North Valley Farms 2nd Addition

RE: SUB 2001-80 -- Final Plat of North Valley Farms Second Addition

RE: SUB 2001-80 -- Final Plat of North Valley Farms Second Addition

CASE NUMBER: SUB 2001-80 -- NORTH VALLEY FARMS SECOND ADDITION

North Valley Farms 2nd Addition

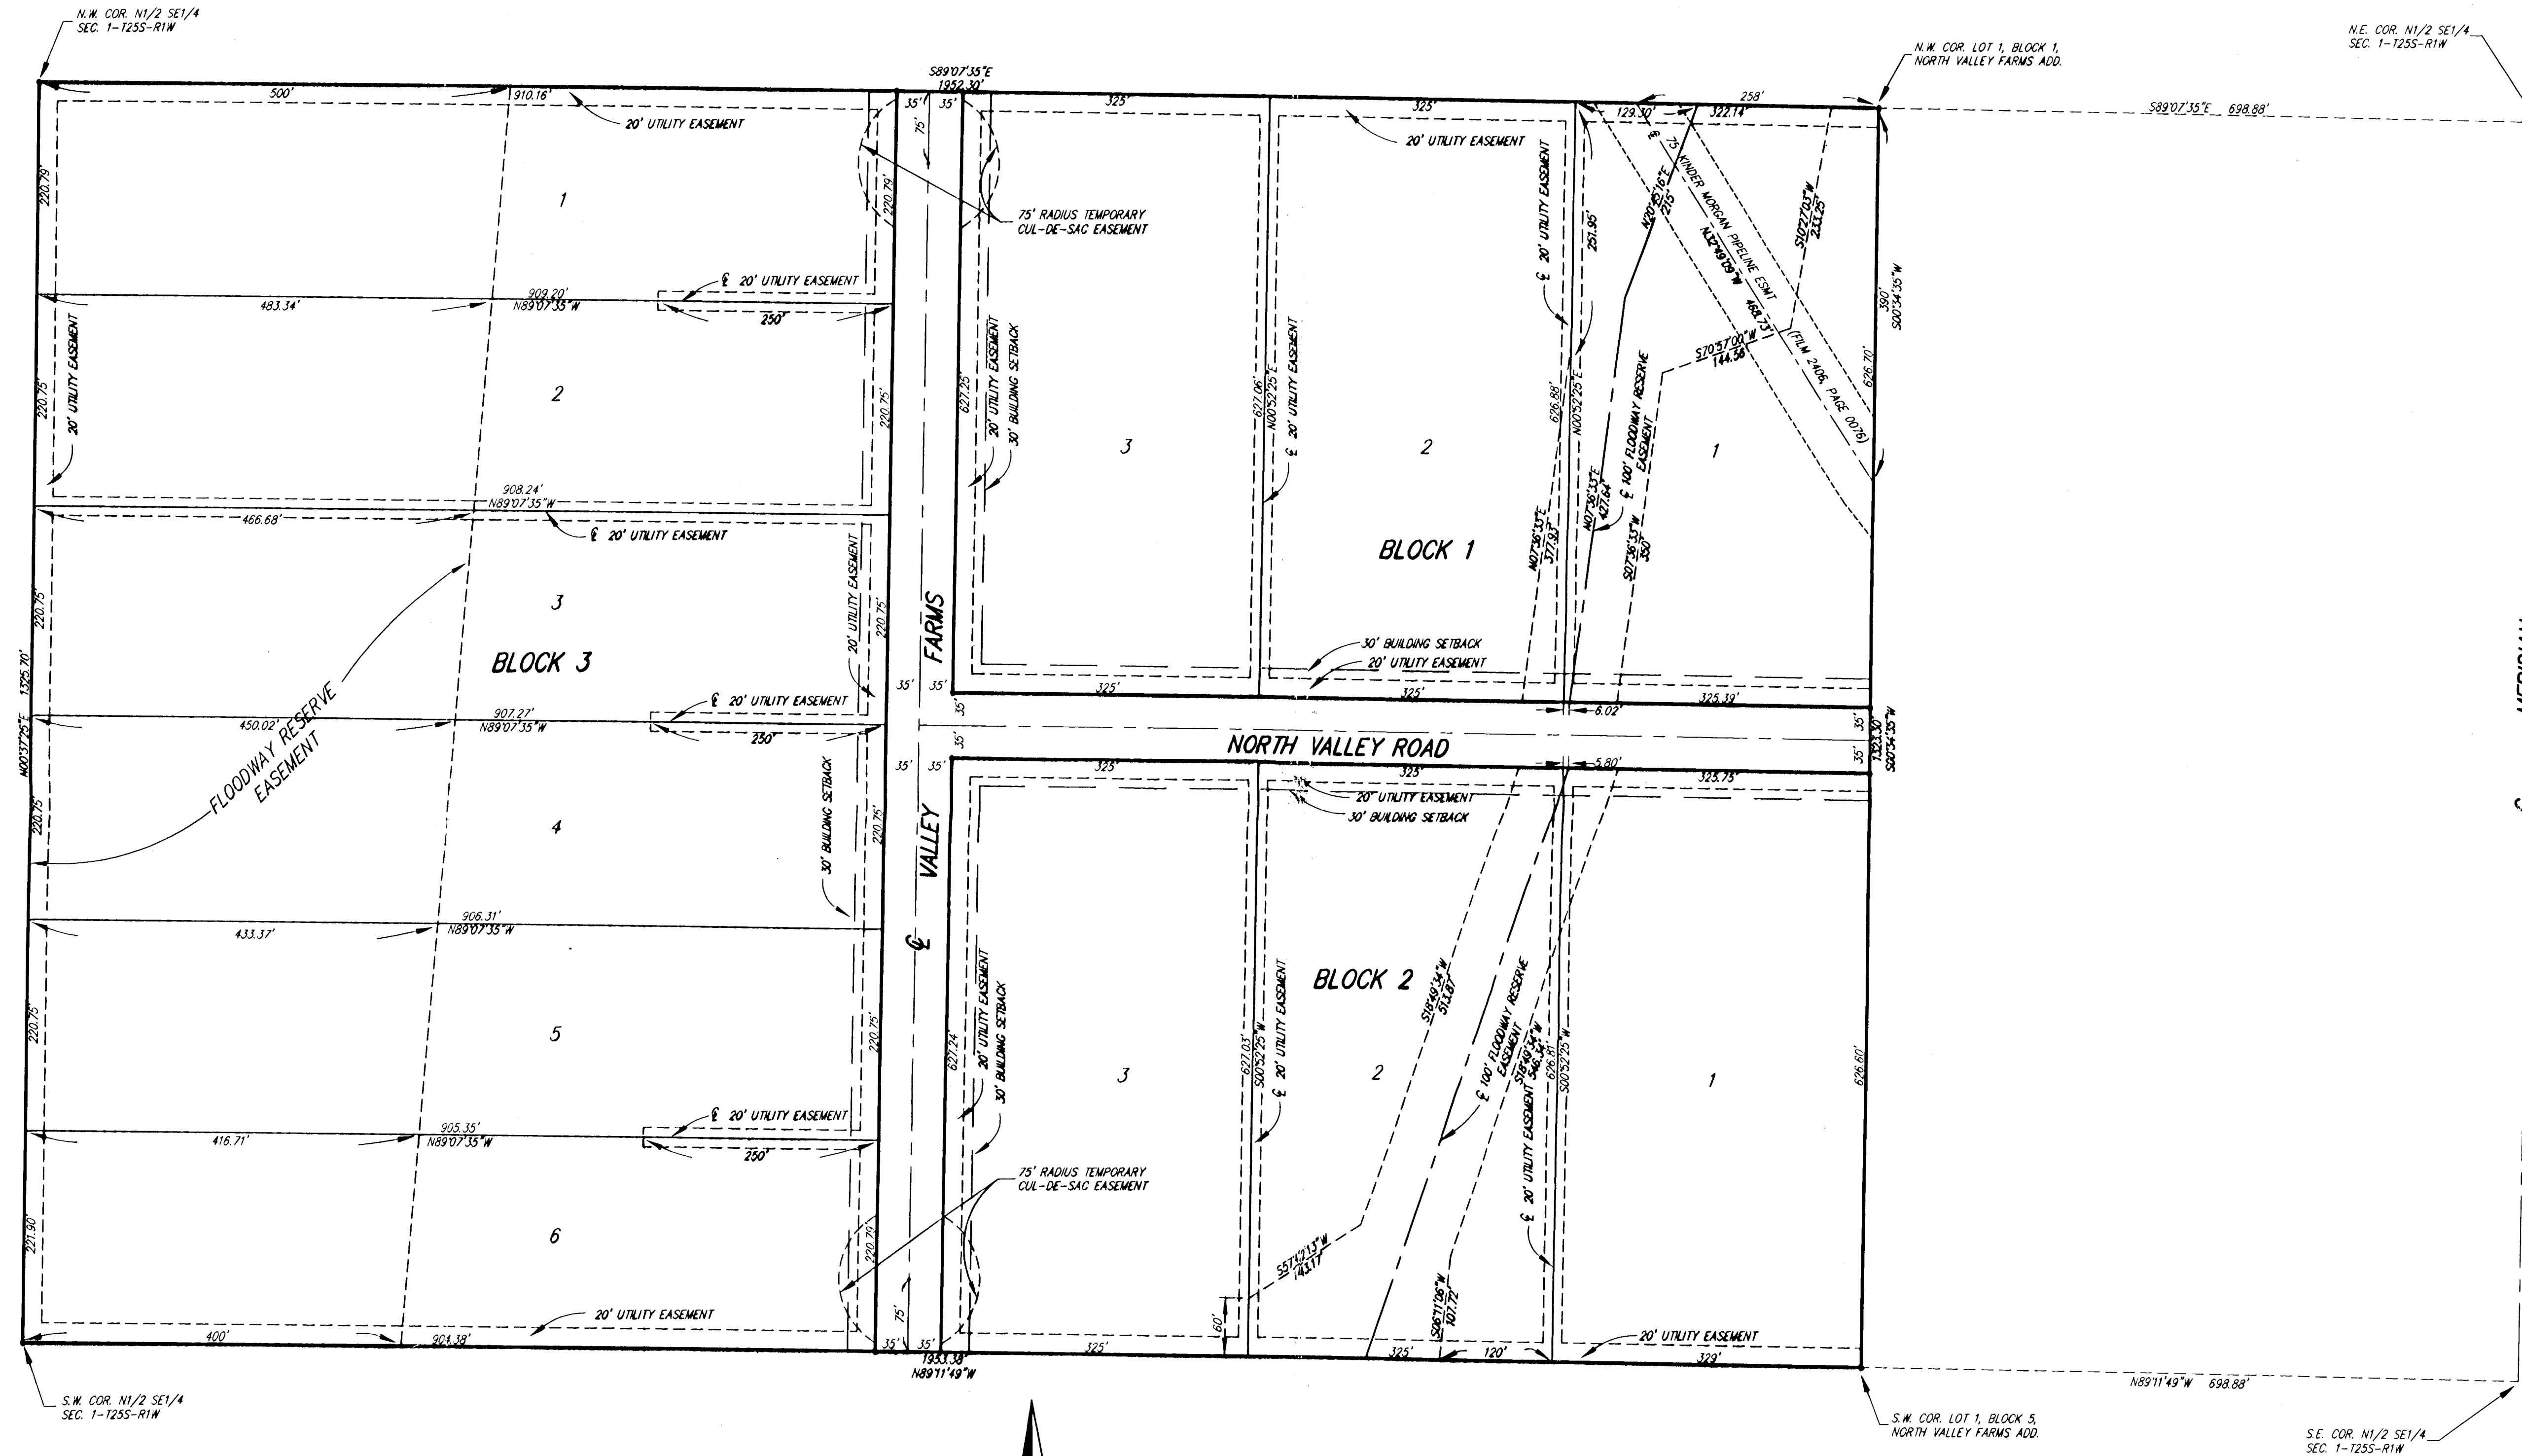
- C. **County Engineering** needs to comment on the status of the applicant's drainage plan. **A HEC 2 Run and Master Lot Grading Plan are required.**
- D. The applicant shall guarantee the installation of the proposed streets to the 36-ft rock standard. The guarantee shall include the elimination of the existing cul-de-sac at the terminus of North Valley Road.

- F. The length of the internal street is approximately 2,250 feet (measured from Meridian), exceeding the 1,200-ft limitation of the Subdivision Regulations. Approval of the plat will require a modification. **A modification has been approved by the Subdivision Committee.**

- H. Approval of this plat will require a waiver of the lot depth to width ratio of the Subdivision Regulations for Lots 1 through 6, Block 3. The Subdivision Regulations state that the maximum depth of all residential lots shall not exceed 2.5 times the width. *A modification has been approved.*

- I. The County Fire Department/GIS needs to comment on the plat's street names. *The street names are approved.*
- J. The signature line for the County Clerk needs to be revised to reference "Don Brace".

- K. The MAPC signature block needs to reference "J.D. Michaelis, Chair".
- L. The applicant shall submit a copy of the instrument which establishes the pipeline easements on the property, which verifies that the easements shown are sufficient and that utilities may be located adjacent to and within the easements.

- M. The applicant's agent shall determine any setback requirements for the pipelines by researching the text of the pipeline agreements. If a setback from the pipeline easements is provided for in the pipeline easement agreements, it shall be indicated on the face of the plat.

- N. The recording information for all pipeline easements shall be indicated on the face of the plat.
- O. The Applicant is reminded that a platting binder is required with the final plat. Approval of this plat will be subject to submittal of this binder and any relevant conditions found by such a review.

- P. The plat's text shall include language that a drainage plan has been developed for the plat and that all drainage easements, rights-of-way, or reserves shall remain at established grades or as modified with the approval of the applicable City or County Engineer, and unobstructed to allow for the conveyance of stormwater.

- X. The representatives from the utility companies should be prepared to comment on the need for any additional utility easements to be platted on this property. ***KGE has requested additional easements.***
